**HISTORIC LANDMARK COMMISSION**  
**PERMITS IN NATIONAL REGISTER HISTORIC DISTRICTS**  
**FEBRUARY 25, 2019**  
**NRD-2019-0014**  
**610 Brazos Street**  
**Sixth Street Historic District**

**PROPOSAL**

Remove the existing façade of the building and install a new glass-centric façade, exposing the concrete structural members of the building.

1 EAST ELEVATION @ BRAZOS ST.  
SCALE 3/16" = 1'-0"

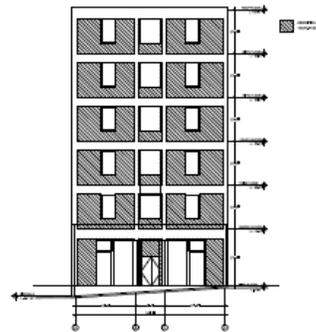
The applicant presented this proposal to the Certificate of Appropriateness Review Committee on February 11, 2019. The Committee stated that the proposed design is not historically appropriate but it was architecturally interesting, and recommended that the applicant simplify the window patterns and employ a design that emphasized the verticality of the existing façade.

Request that the applicant return to the Certificate of Appropriateness Review Committee for further study and evaluation of the proposal to allow for more conformance with the historic district design guidelines and emphasis on the vertical composition of the building.
